Event # 42151

INITIAL PART 21 NOTIFICATION - PRIME MEASUREMENT PRODUCTS, MODELS 763 & 763A PRESSURE TRANSMITTERS AND MODEL 764 DIFFERENTIAL PRESSURE TRANSMITTERS

NUCLEAR INDUSTRY ADVISORY

Barton Model 763, Model 763A and Model 764 Zener Diodes

Larger Commercial Zener Diode & Smaller Similar Glass Body JANTX Zener Diode

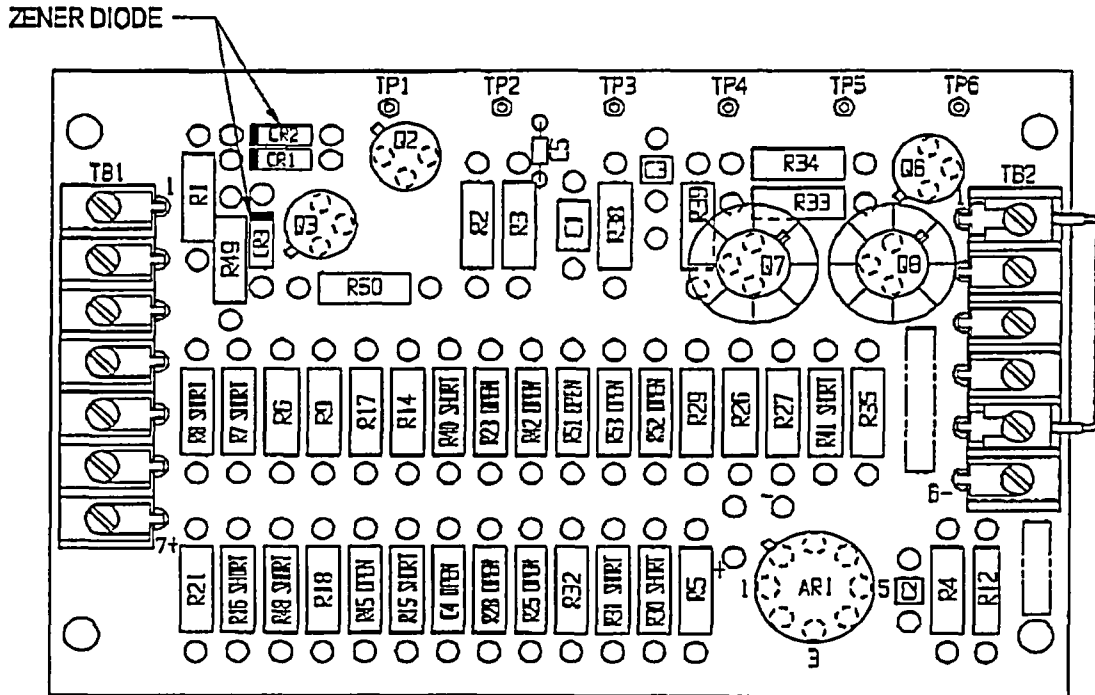
1. This notification involves 76 specific transmitters manufactured between 2/10/04 and 9/19/05.
2. Each transmitter contains two Zener diodes which may not comply with purchase specifications.
3. The JANTX Zener diodes are different in appearance with respect to the commercial variations. Some JANTX Zener diodes used in the recent past have bodies that are solid orange or light blue in color or clear glass. The commercial Zener diodes in question have a clear glass body. The commercial Zener diode is larger (0.095" diameter X 0.275" long) than the smaller JANTX Zener diode (0.072" diameter X .155" long).

The JANTX Zener diodes are different in appearance with respect to the commercial variations. Some JANTX Zener diodes used in the recent past have bodies that are solid orange or light blue in color or clear glass. The commercial Zener Diodes that have been used have a body that is clear glass. The attached photo compares the larger commercial Zener diode (0.095" diameter X 0.275" long) with the smaller JANTX Zener diode (0.072" diameter X .155" long) that has a glass body. The existence of the commercial Zener diode can be verified by visual inspection. Remove the transmitter electronics cover and visually observe the Zener diodes at locations CR2 and CR3 as shown on the attached drawing of the circuit board.
